Memorandum

Re: 103 Brick Church Road
SBL# 50.05-1-11.1

Date: January 28, 2025

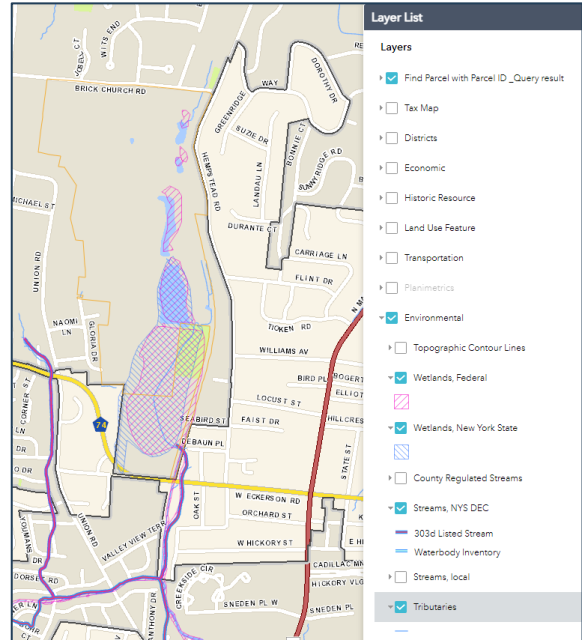
2. **Federal and State Wetland Constraints.** See the output from the Rockland County GIS system on right. Along the Hempstead Road side of the site, there is a string of federal wetlands. Below the largest pond, there is also a sizeable 42.3-acre State DEC classified wetland (#TH-19). State regulations mandate a 100-foot buffer around the state classified wetland, where a state permit will be required for any disturbance.

The Federal wetlands (in pink) do not require any federally mandated buffer. **However, for adjacent work or disturbance to any wetlands greater than 1/10th of an acre, whether federal or non-federal, a wetlands permit is required for work within a 100-foot buffer, by the Village of New Hempstead Code Chapter 159, Freshwater Wetlands.** A buffer should be shown around all wetlands and waterbodies greater than 1/10th of an acre, which fall under Village jurisdiction. **We would recommend that the lot lines be adjusted so that private lots will not contain any federal, village or state jurisdictional wetlands or wetland buffers within their boundaries. These water resources should be placed within common open space (see comment #6 below).**

Applicant's Latest Concept

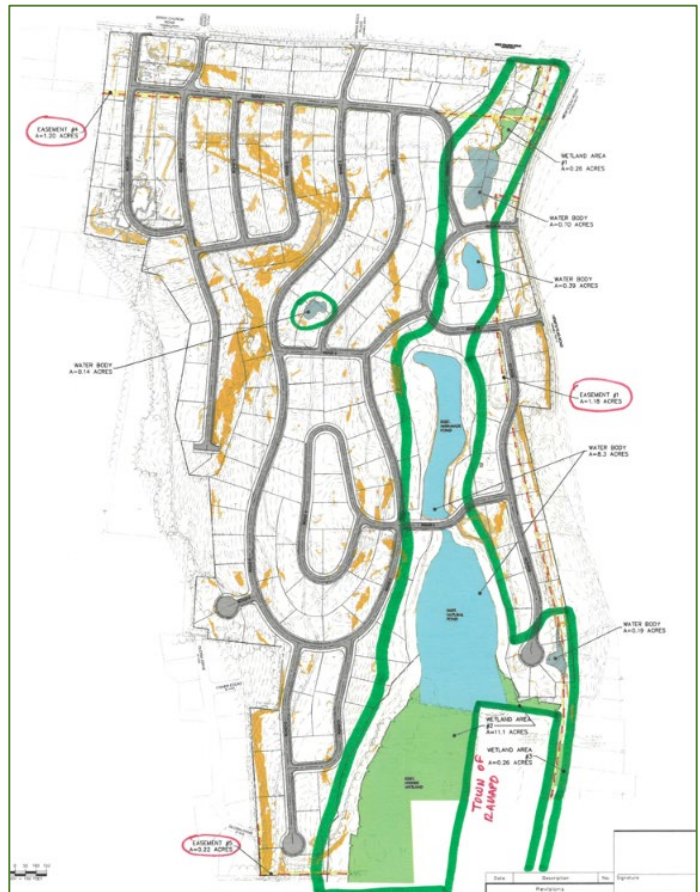
The concept plan shows ten separate open space slots, and several unnumbered slivers of open space, in the middle of platted house lots. We would suggest that this is an unworkable arrangement to manage, whether the open space is taken care of by the homeowners' association or the Village. See the figure above. **It would make the most sense to create a single park along the east side of the site (as shown in the green outline above), and cluster all the housing away from the wet corridor of ponds and wetlands. Upland areas east of this linear park could take access from a road connecting to Hempstead Road. If the intention is to turn over the open space from this subdivision and dedicate it to the Village, the Village would be much more likely to accept the dedication if it were one unified parcel, rather than a dozen or more fragmented sites.** This large open space, as drawn above, would be connected to the existing Town of Ramapo park, located just below the largest pond.

7. Easement Issues. We note that utility easements do not line up with the concept plan's road features or lot lines, and the lot pattern does not seem to take the easement locations into account. Road 1 does not line up with the gas easement. The sewer easement along the eastern side of the site cuts at least fifteen lots in a matter that would make house siting difficult. **The lot pattern should be redesigned with more attention paid to working around the utility easements.** See red dotted lines in the figure above for problem easement locations.
